SUNDRY NOTICES AND REPORTS ON WELLS Do not use this form for proposals to drill or to re-enter an abandoned well. Use Form 3160-3 (APD) for such proposals.

1. Type of Well [X] Oil Well [] Gas Well [] Other
2. Name of Operator CHEVRON U.S.A. INC.
3a. Address 15SMITH ROAD MIDLAND, TEXAS 79705
3b. Phone No. (include area code) Bob Holden 432-234-7325
9. API Well No. y 30-025-30663
10. Field and Pool or Exploratory Area PEARL; QUEEN
11. Country or Parish, State LEA COUNTY, NEW MEXICO

Well: Sun Pearl Fed #2

Permanent Abandonment of Federal Wells
Conditions of Approval

Wellbore Diagram

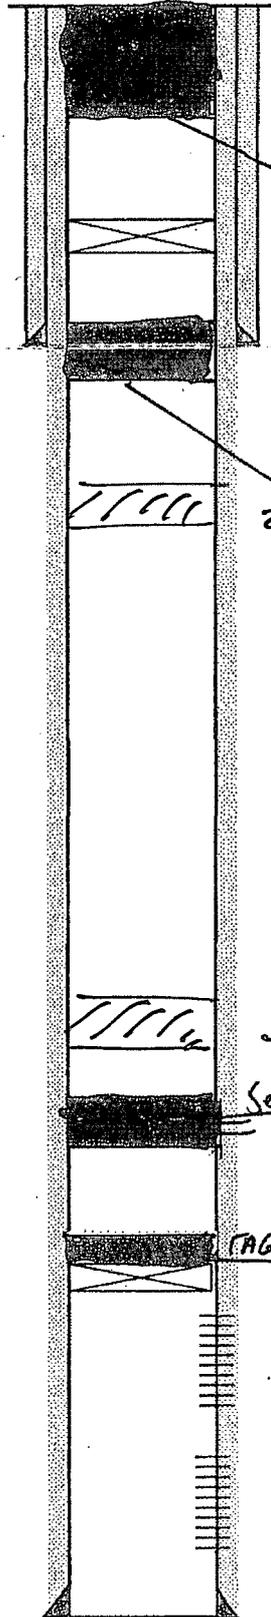
* Add B/Salt plug 3400'-3200'; woc Tag.
T/Salt plug 2000'-1800'; woc Tag.

2000 - 1800 T/Salt. WOC Tag
 Set Plug @ 1250 - 1250' w/ 25 sks
 of cmt ^{w/} TAB (TOP of salt, shoe)

T/Salt
 3400 - 3200 WOC Tag w/ TAB
 Set Plug @ 4000 - 3700 w/ 40 sks (comes bottom salt)
 Leaks
